**Release Notification and Corrective Action**

Name of Company: Tandem Energy Corp. <i>236183</i>	Contact: Ernie Sanchez
Address: 2700 Post Oak Blvd. Ste. 1000 Houston, TX 77056	Telephone No. 575-703-6865
Facility Name: Gulf State Lease #B-1969	Facility Type: Oil and Gas Battery

Tandem Energy Gulf State Lease B-1969

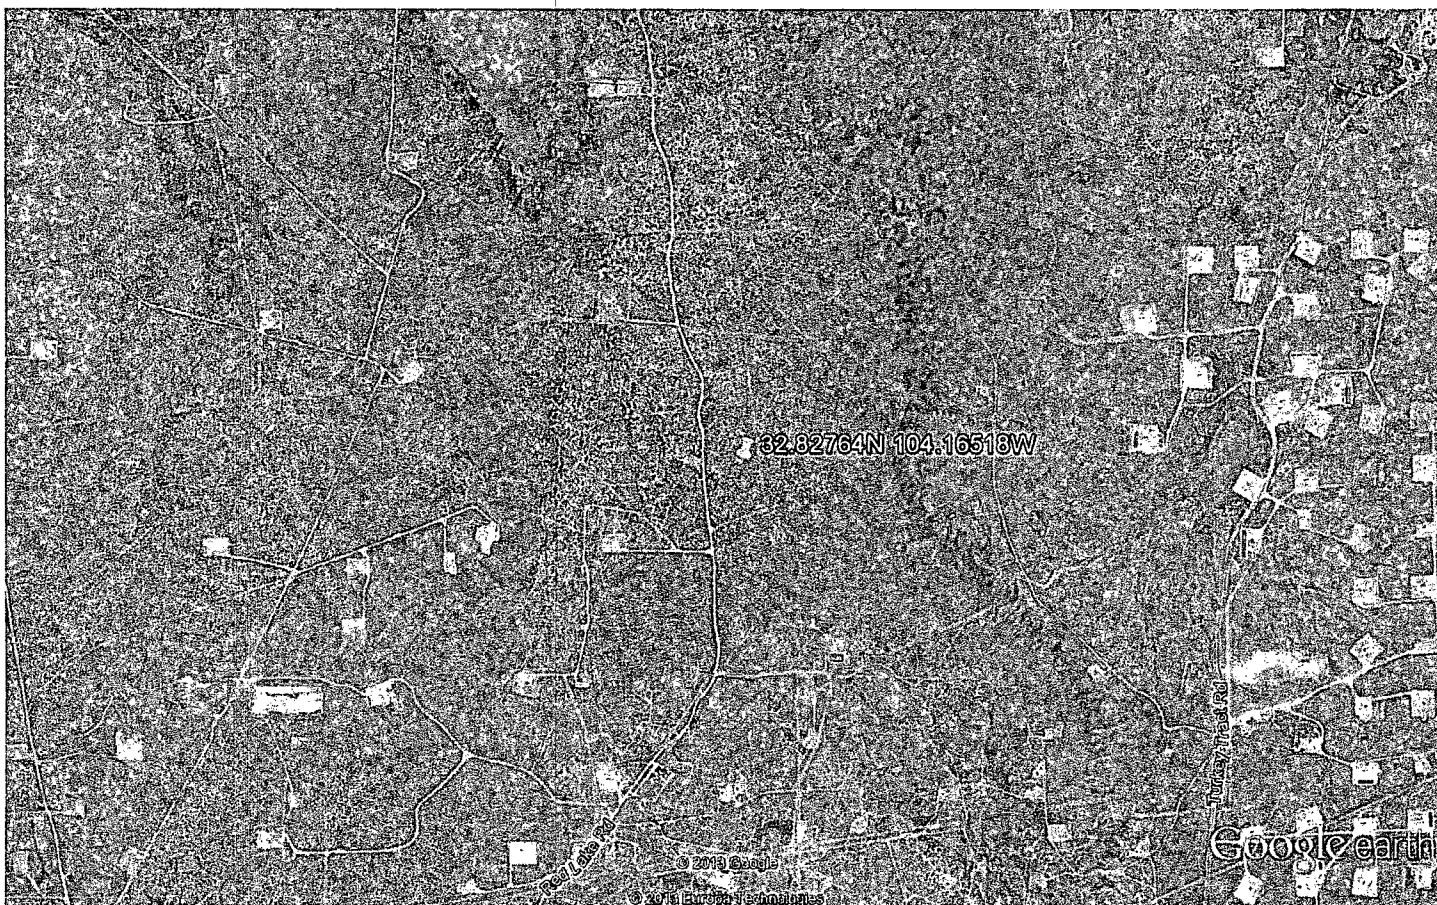
Lat/long listed on C-141

Based on RBDMS MAPS - This looks more like it would be in Sec 15 or 16 - not Sec 28 as listed

Tandem has no wells in sec 28 - but do have in Sec 22

# Tandem Energy 22-17s-28e

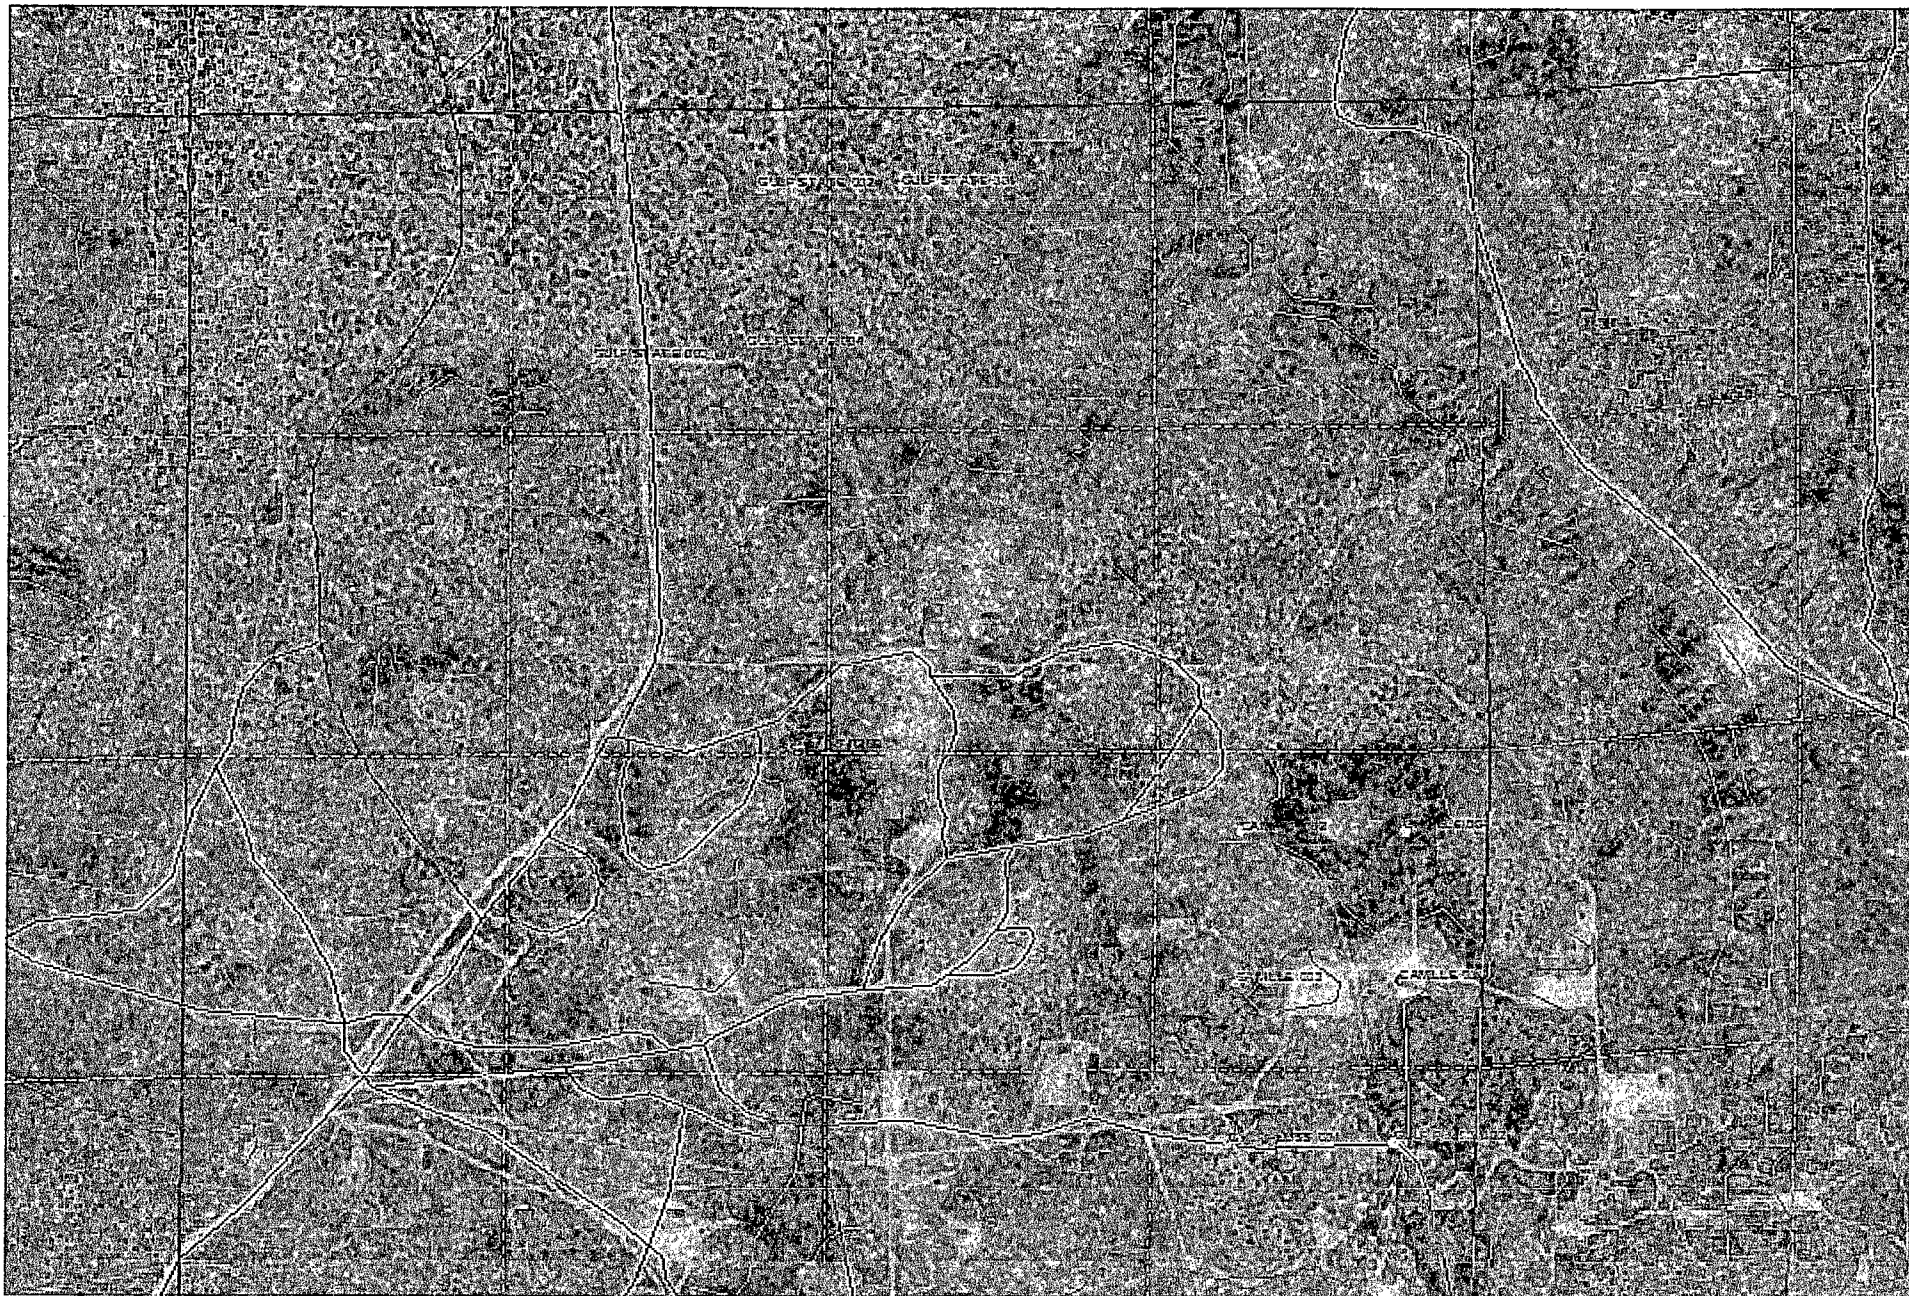
Gulf St 1 UtB & CTB  
32.82627N 104.16273

# Tandem Energy 22-17s-28e to include bottom of section

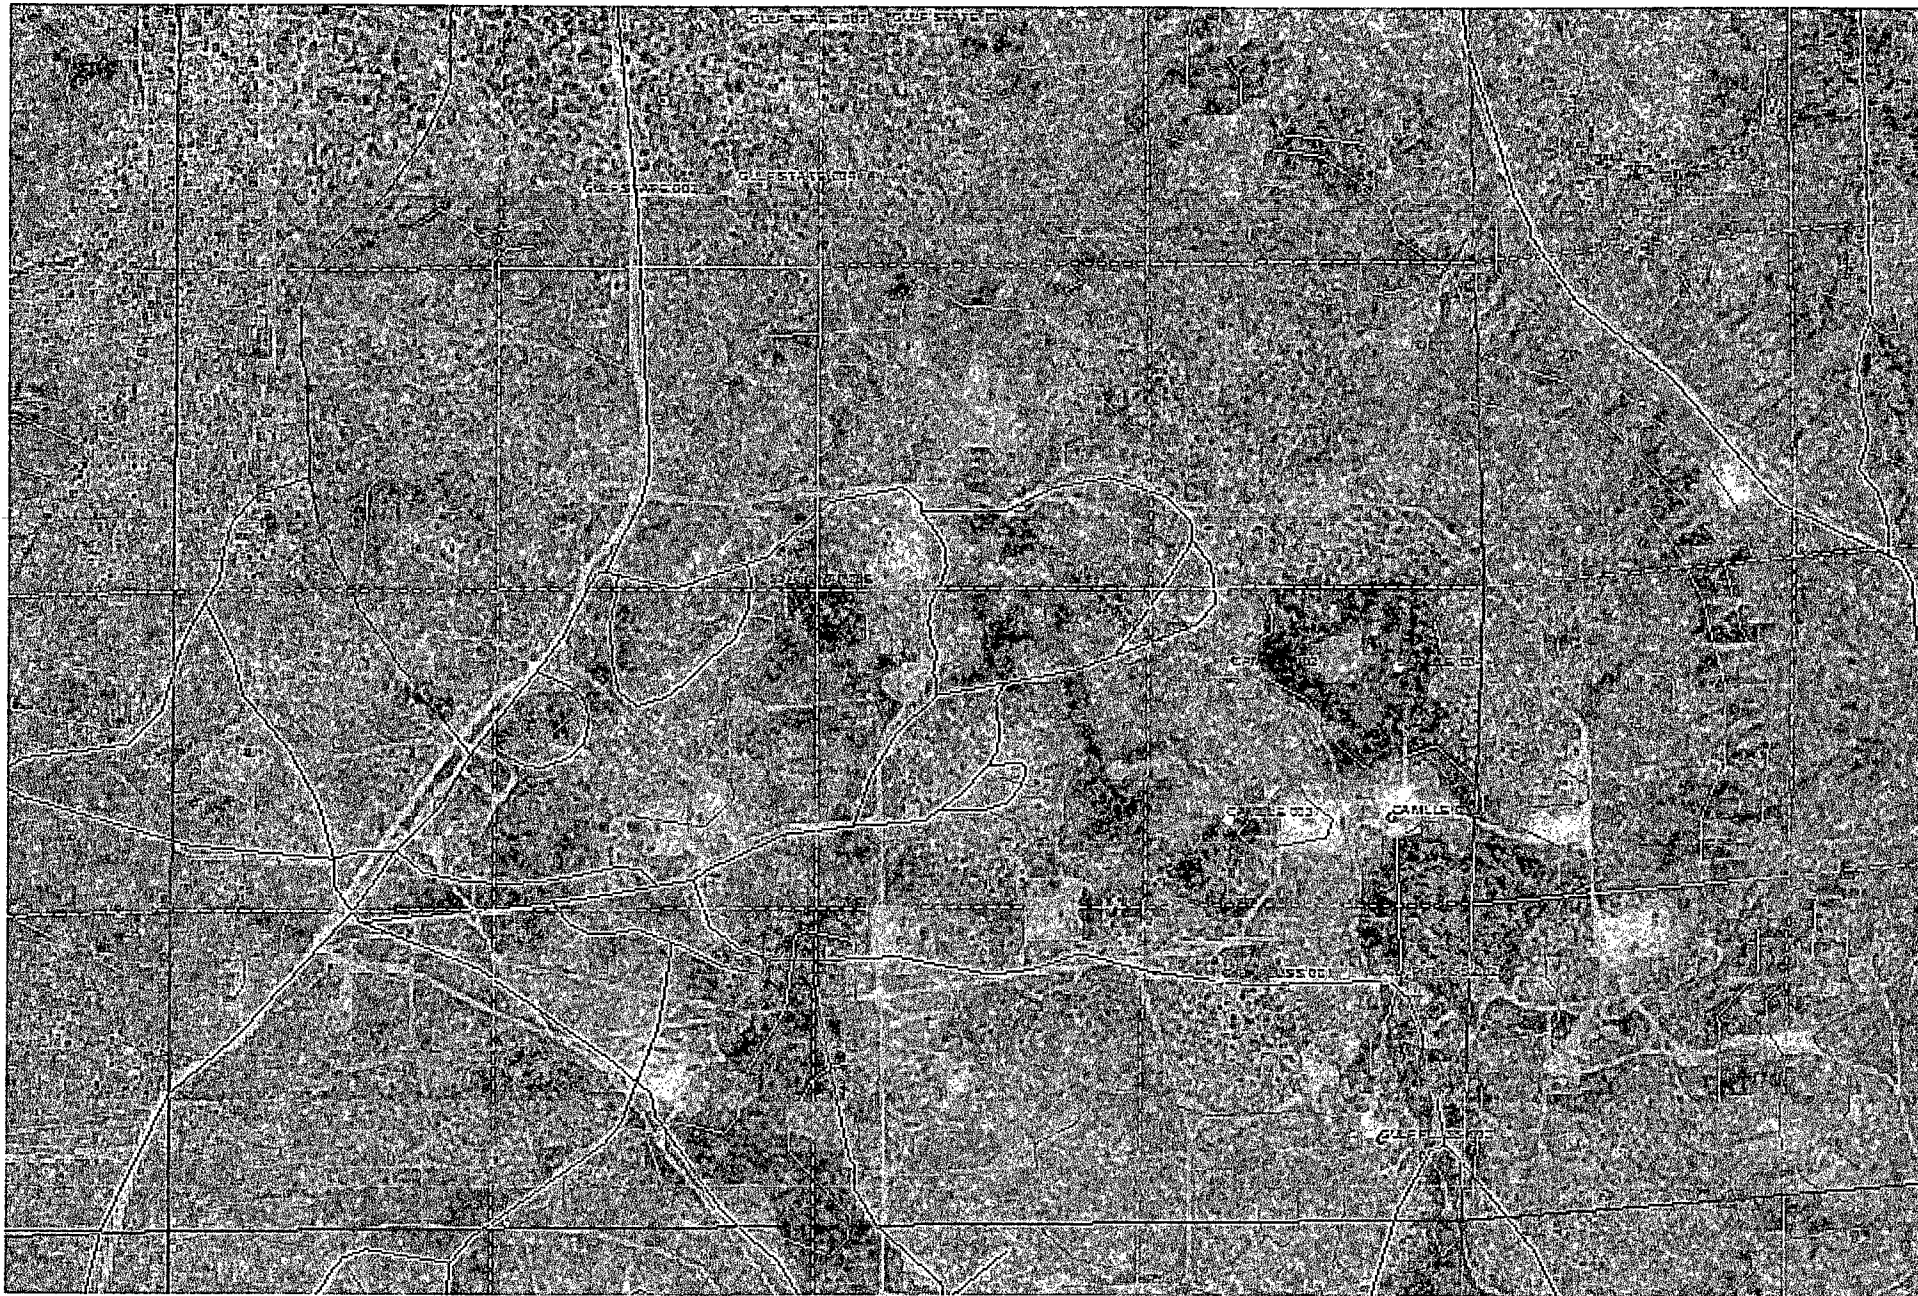
Gulf Flus #3 32.81370 N 104.15640 W
